**Appeal by Ministry of Justice
Land adjacent to HMP Garth and HMP
Wymott, Leyland Appeal Ref:
APP/D2320/W/22/3295556**

Updated Proof of Evidence of Kevin Riley

on behalf of Chorley Council

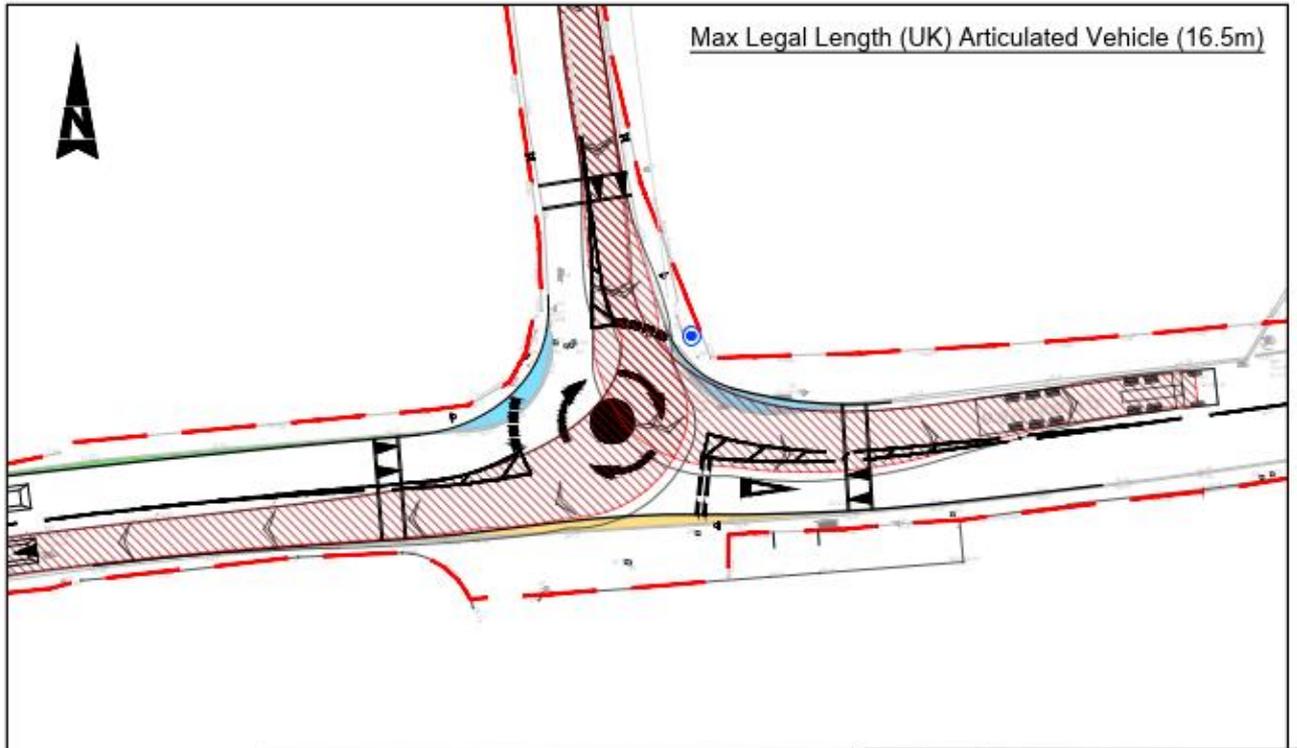
5.2.9 The Appellant has then referred to the swept path analysis that is shown in the Designer's Response Appendix E (M3a – Appendix E – Appendix E – pdf page 55). I have included an extract below for ease of reference.

5.2.11 The mini roundabout design of the junction (bottom right) cannot be considered a “*betterment*” compared to other solutions. All four plans show the HGV running onto the opposite side of the carriageway, because the road widths and size of the junctions are all similarly constrained by the adopted highway. If a vehicle is on the wrong side of the road, regardless of what extent, it is at risk of being in conflict with another vehicle and that is unsafe. It is simply not a case that any of the layouts above are better than another. They are all unsafe.

5.2.12 Whilst this is an existing issue for the existing priority junction (top left), this will be exacerbated by the proposals, not only with more HGVs making the manoeuvre, but also with an increase in other vehicles that could come into conflict with that movement in terms of the cars generated by the development.

5.2.13 The only consolation for the existing junction issue, is that currently the vehicles making that manoeuvre must give-way to the main road traffic with the junction being a priority junction, and therefore HGV drivers can try to ensure the road is clear before turning into the path of a potential oncoming vehicle. Although by today’s standard a junction would not be designed as such as it is still not considered safe.

Figure 3.4 Priority junction visibility splays

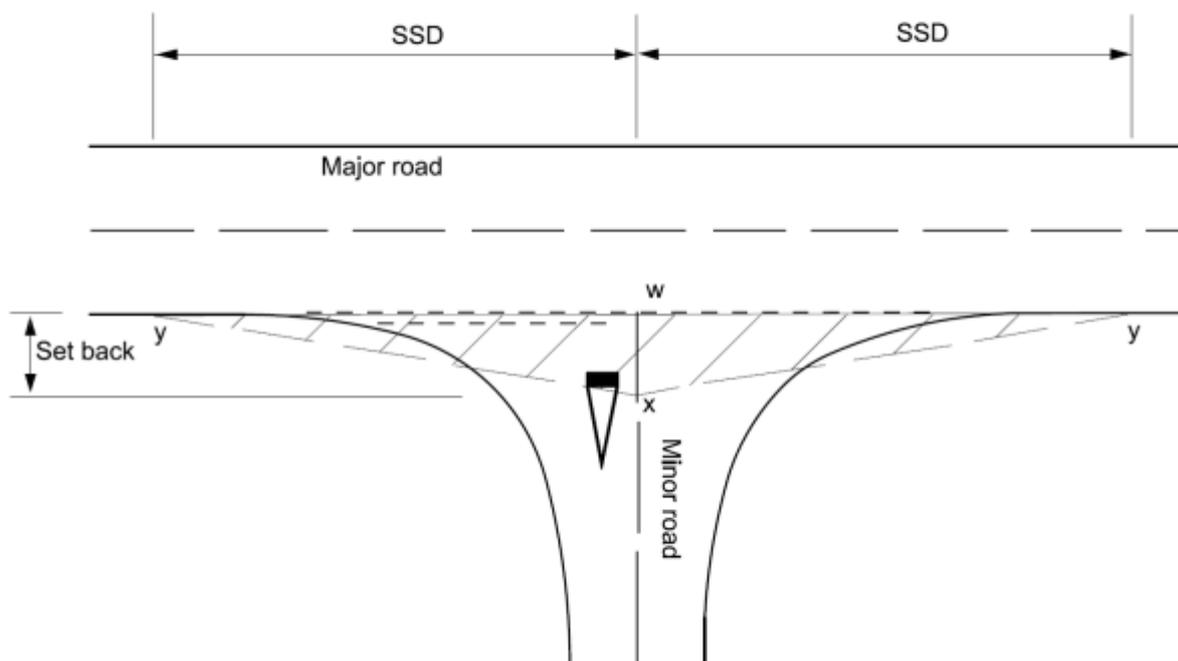
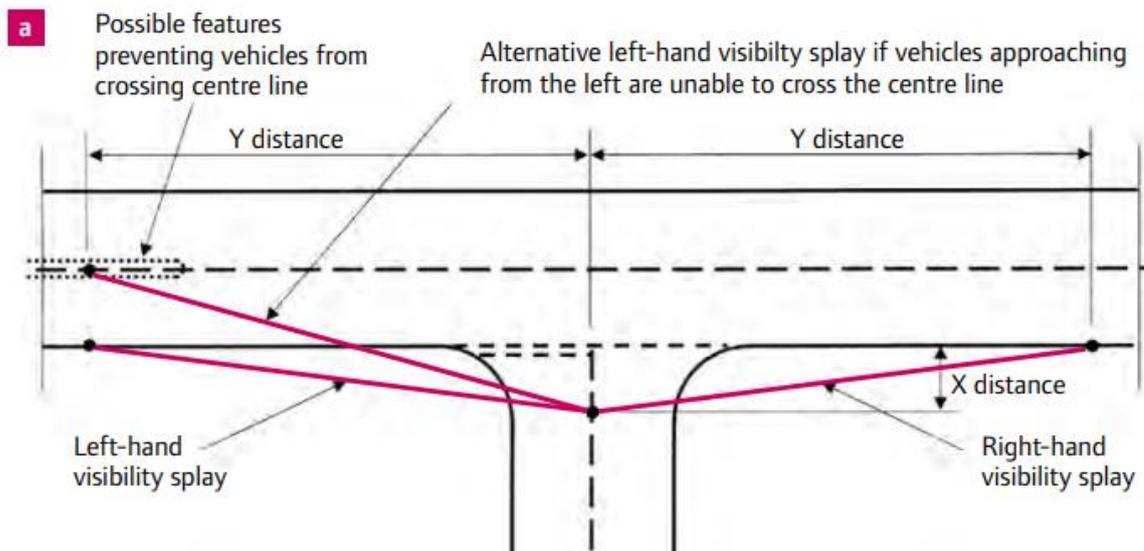
- 5.4.36 The Appellant has incorrectly applied a set back or ‘X’ distance of 9 metres. In quoting the standards in DMRB CD123, the Appellant is referring to section 3.4 to section 3.9 (and including figure 3.4 as shown below).

5.4.37 Section 3.8 part (2) ‘for simple priority junctions’ allows two ‘X’ or set back distances of
 a) 9.0 metres or
 b) 2.4 metres.

5.4.38 Section 3.8 part (3) ‘for all other priority junctions’ allows
 a) 9.0 metres or
 b) 4.5 metres.

Figure 6-1 - Proposed Construction Routes

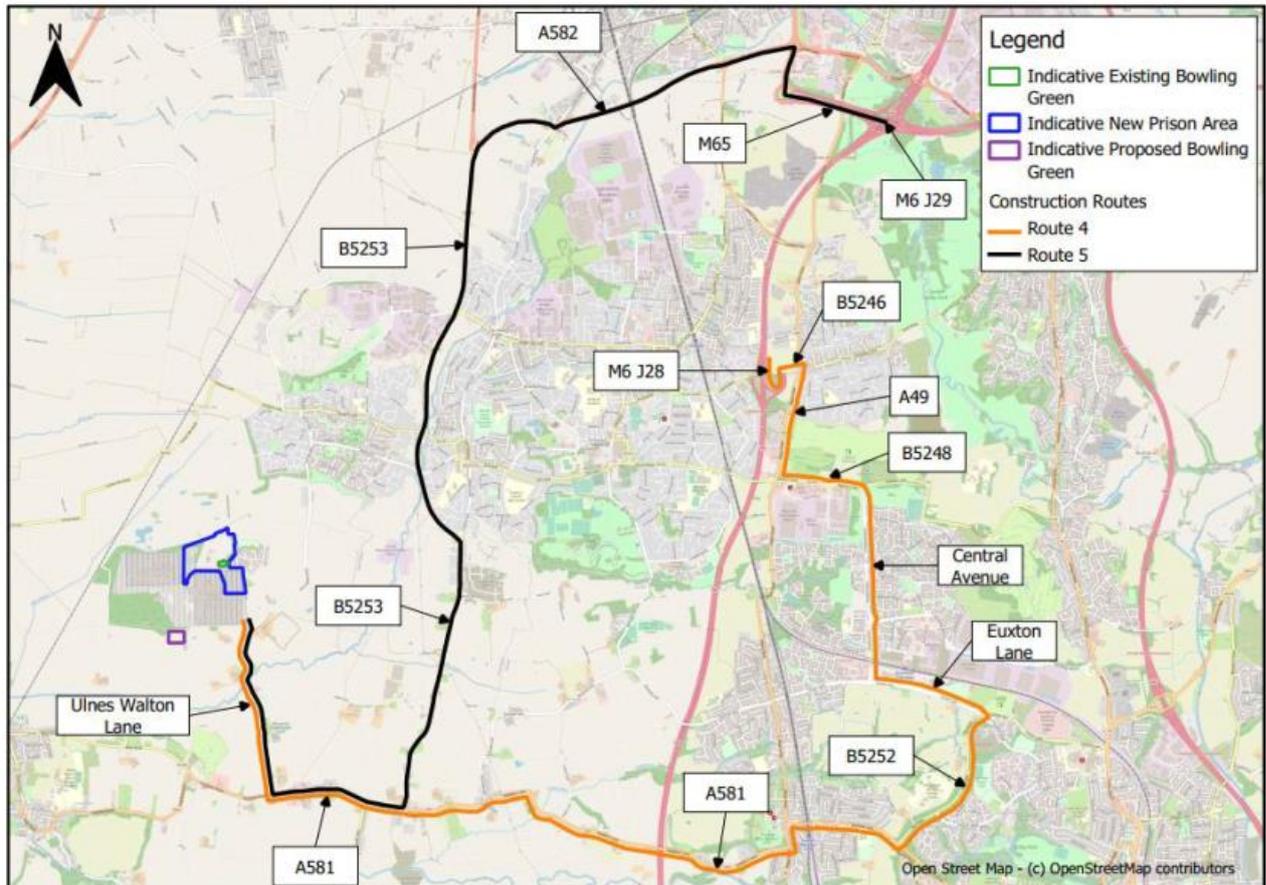
- 6.2.1 It is noted in M3 – section 6.4 (pdf page 27) the routes for construction traffic are set out as travelling to/from the site via the southern section of Ulnes Walton Lane and east on the A581 (as shown in the Appellant's Figure 6-1):

- 6.2.2 All of these vehicles will arrive from the south, turning right into Ulnes Walton Lane at the A581/Ulnes Walton Lane junction, and left into Moss Lane. On departing, all HGVs will travel to the south, turning right at the Moss Lane/Ulnes Walton Lane junction and turning left at the A581/Ulnes Walton Lane junction.

- 6.2.4 According to the Appellant’s traffic figures, in construction there will be a total of 1,350 HGVs one-way (2,700 two-way HGV movements) per month on average over a five-year construction period. This will be a significant increase in HGV traffic on what is largely a rural road and will certainly change the character and its operation during that time.

TITLE:
ULNES WALTON LANE/A581
PROPOSED MINI ROUNDABOUT
SWEEP PATH ANALYSIS
SHEET 1 OF 6

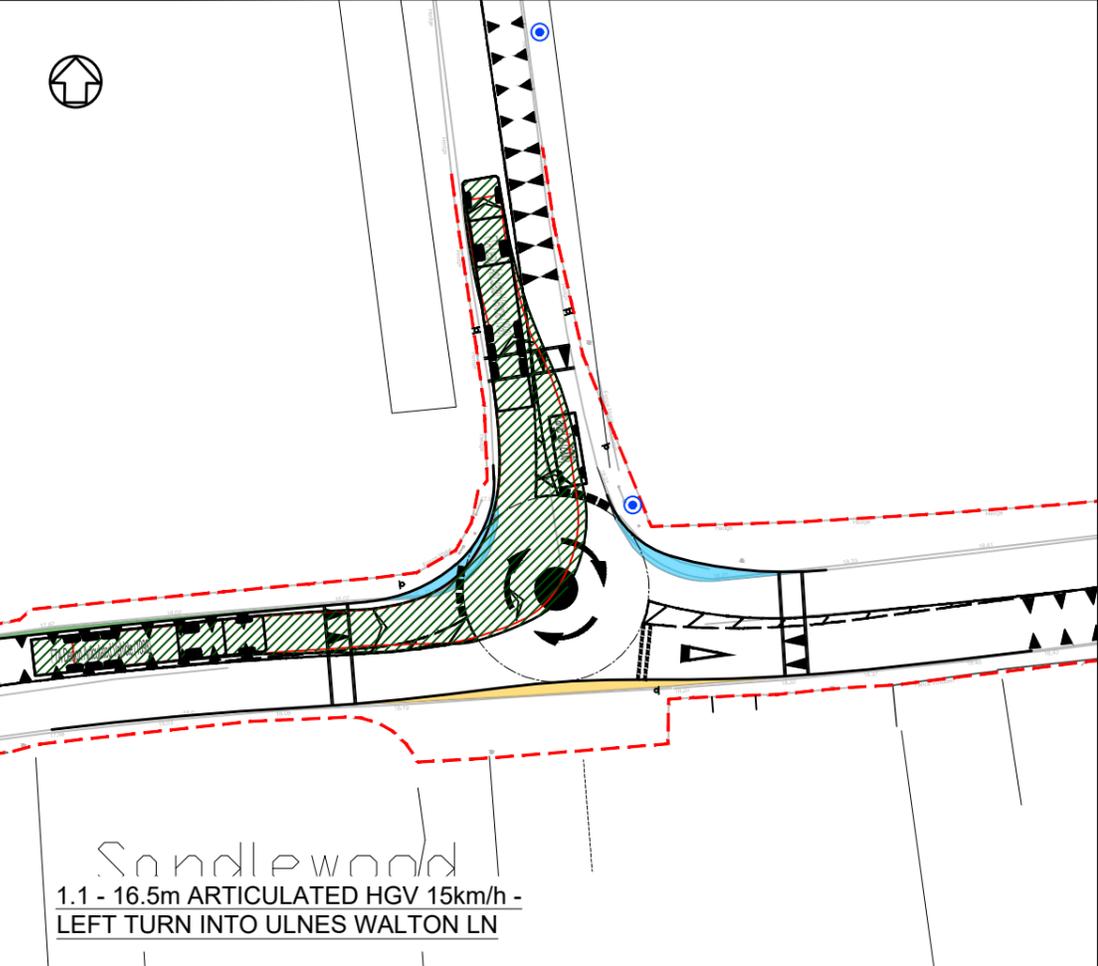
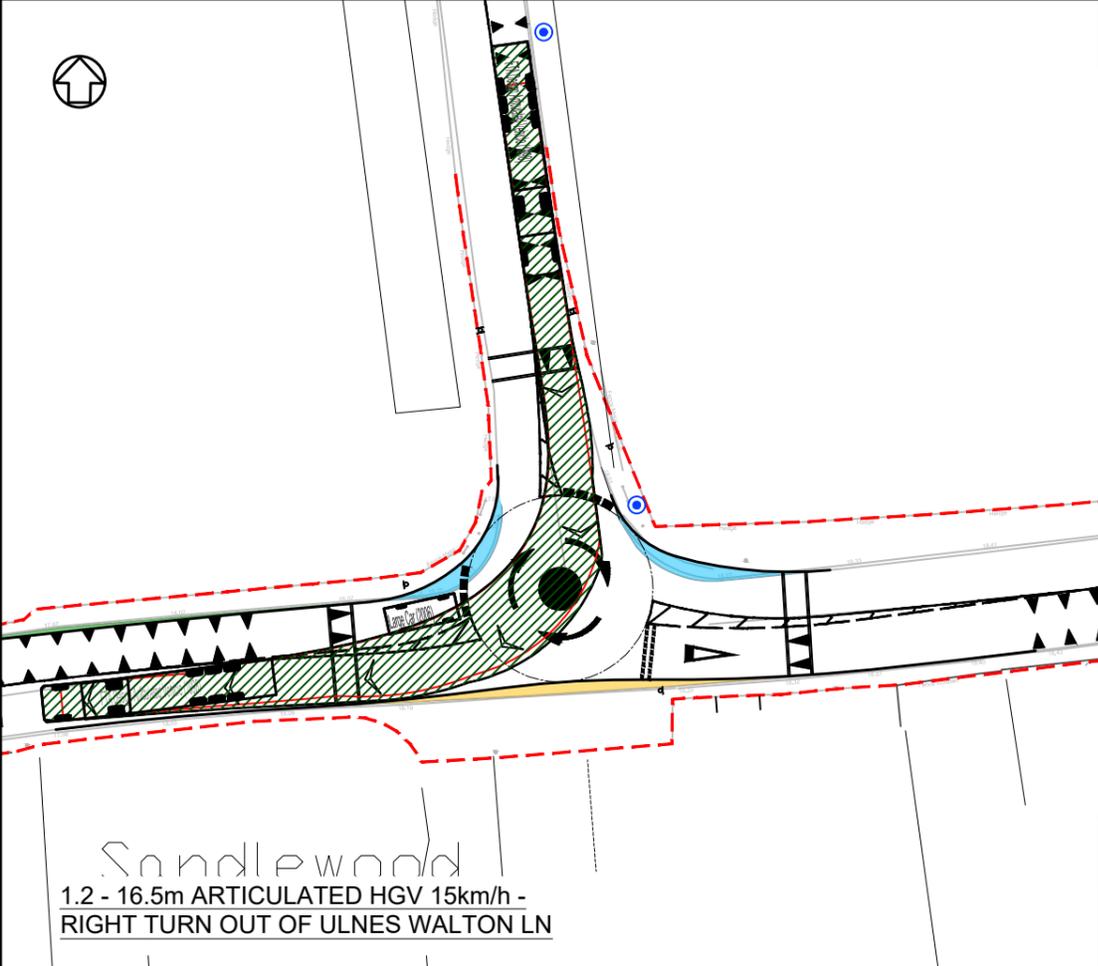
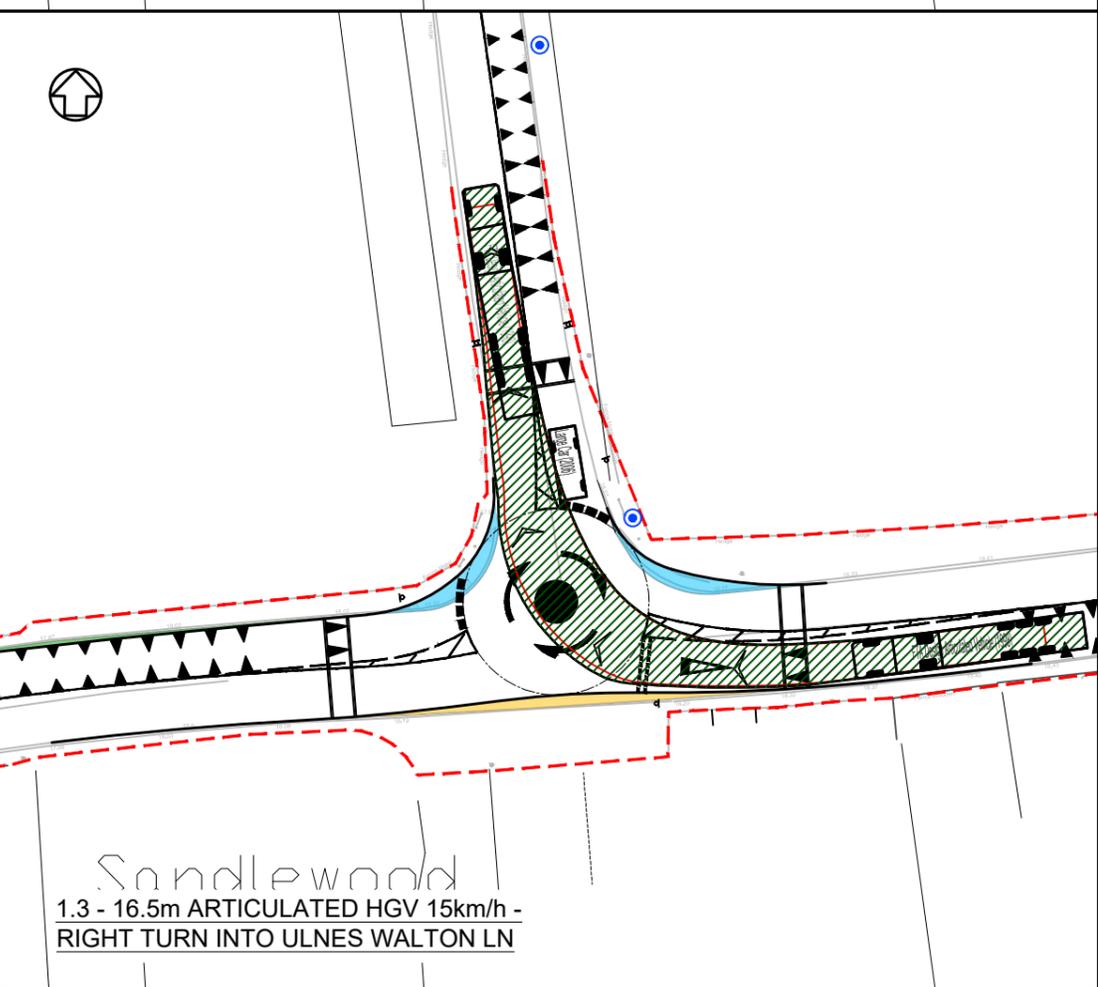
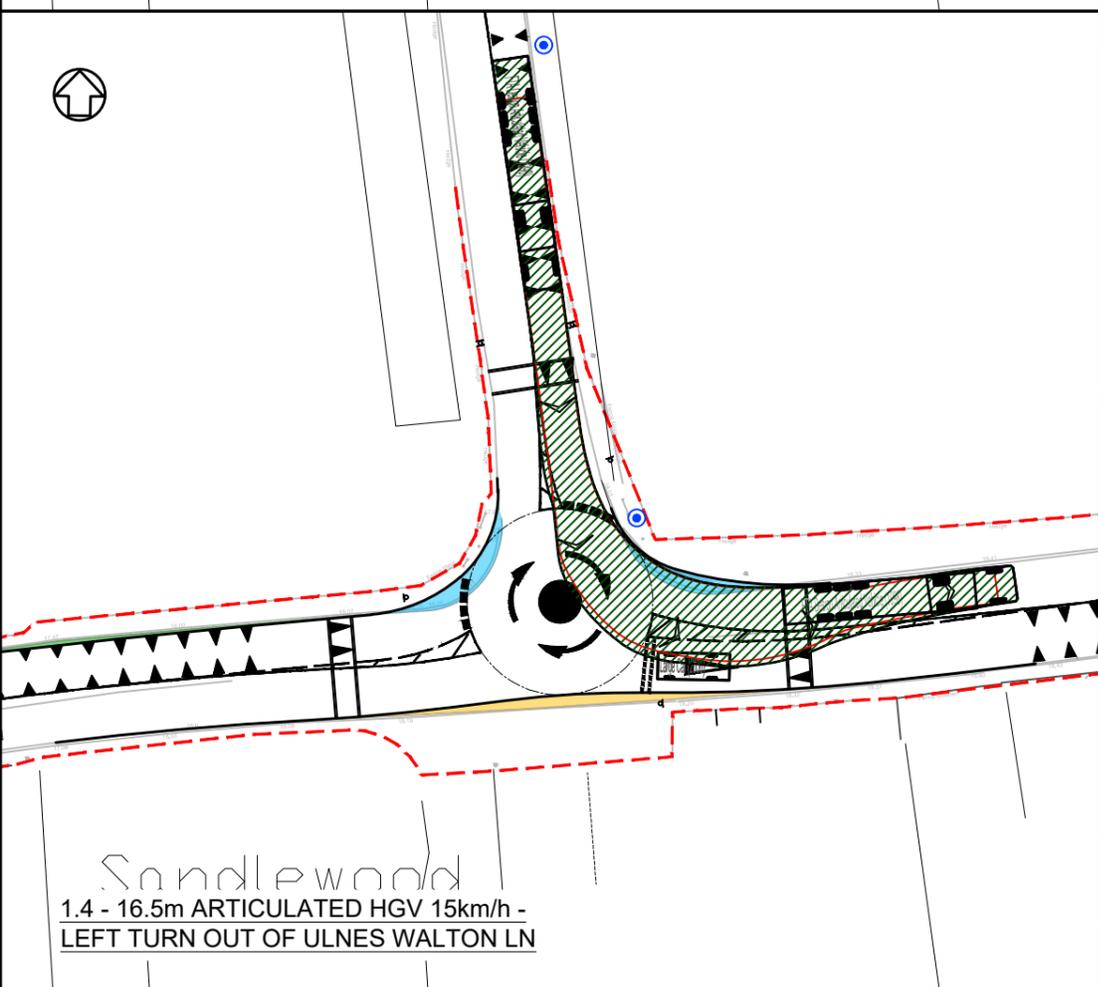
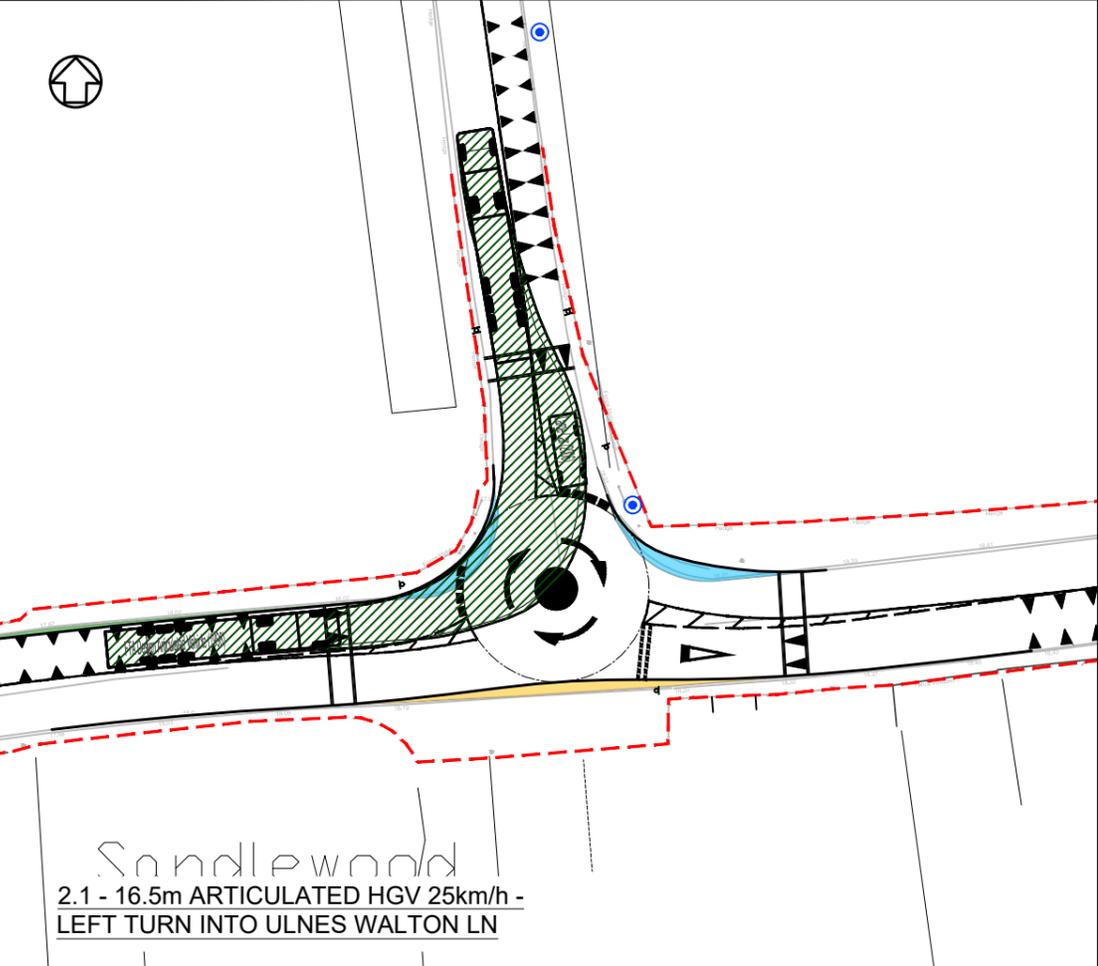
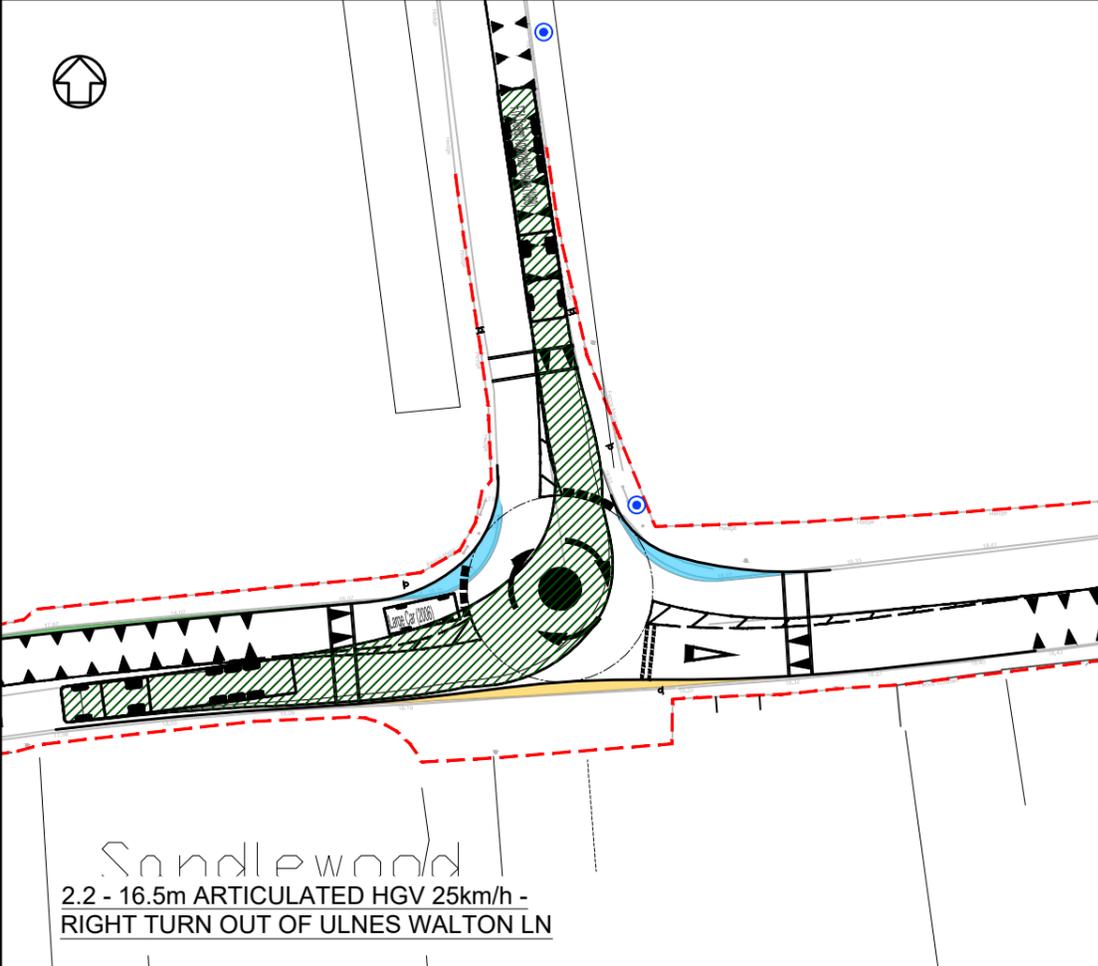
- 5.2.23 The analysis I have undertaken illustrates the turning movements at two speeds, one at 15 kph (approximately 10 mph) and the same at 25 kph (approximately 15 mph) and both show heavy goods vehicles overrun the central markings and into the opposite direction of traffic, with the higher speed of 25 kmph shown to have greater overrun. This means vehicles waiting at the give-way line on each approach will be in potential conflict with vehicles making this manoeuvre and this is not an acceptable safe design of a new junction.
